**TOWN OF NEWBURGH
PLANNING BOARD
TECHNICAL REVIEW COMMENTS**

PROJECT: LAKESIDE SENIOR HOUSING
PROJECT NO.: 19-22
PROJECT LOCATION: SECTION 86, BLOCK 1, LOT 39.22 & 39.23
REVIEW DATE: 27 SEPTEMBER 2019
MEETING DATE: 03 OCTOBER 2019
PROJECT REPRESENTATIVE: MAURI ARCHITECTS

GRADING PLAN
SCALE: 1" = 20'

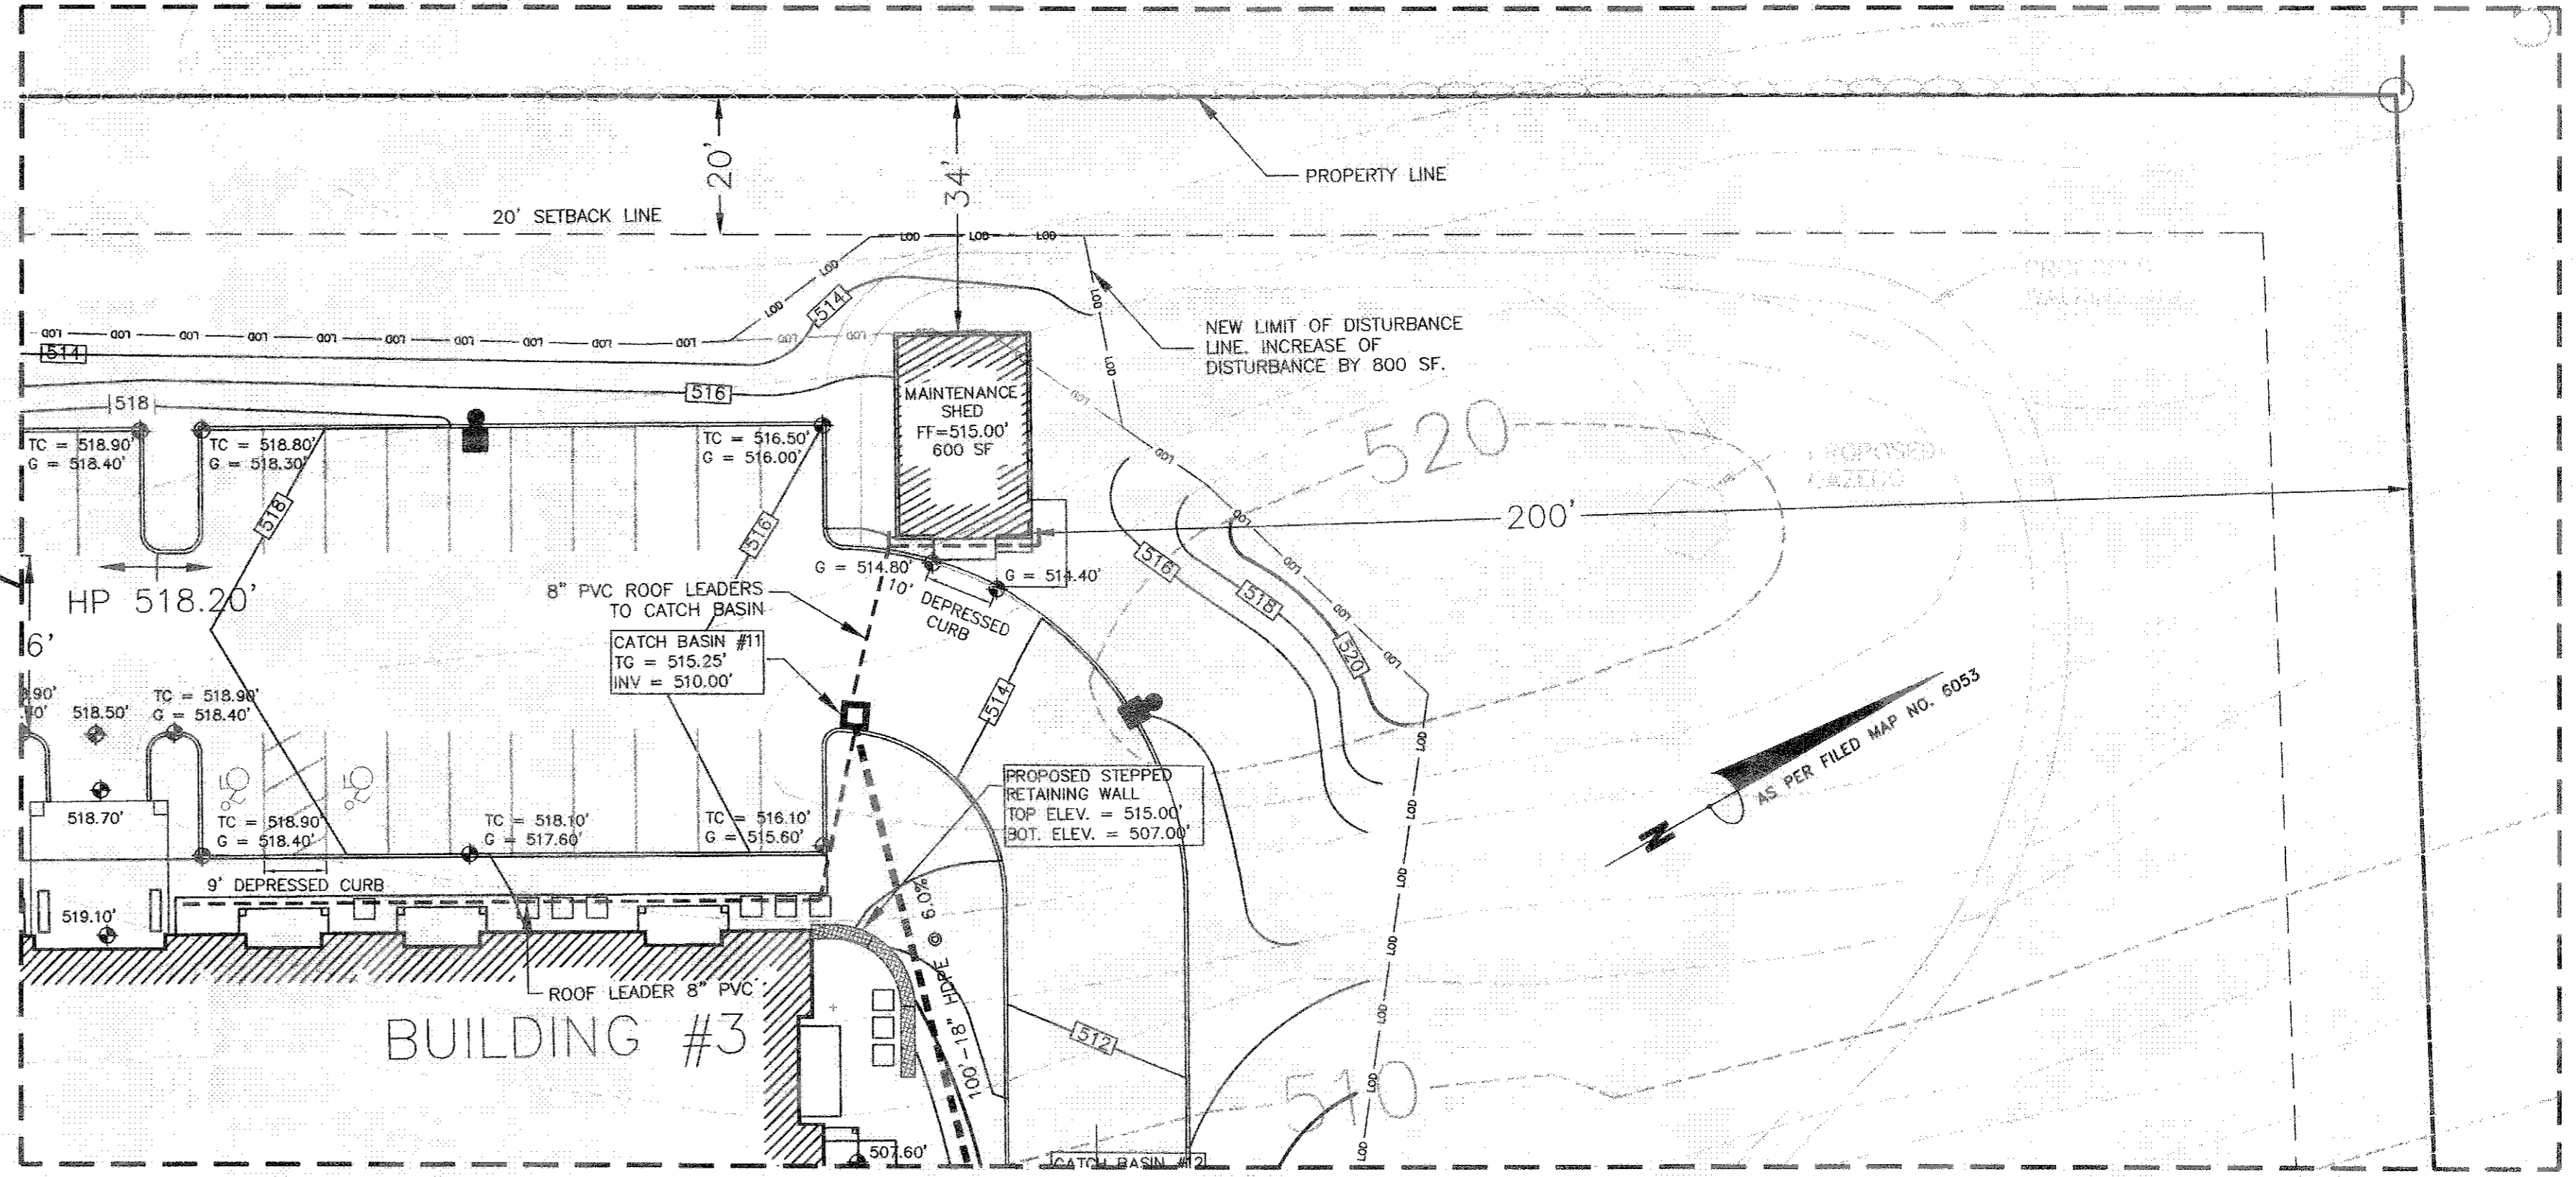
2. A revised landscape plan has been provided moving seven of the trees which were previously proposed in the vicinity of the shed.
3. A depressed curve has been added to the site plan in order to provide access to the maintenance facility.
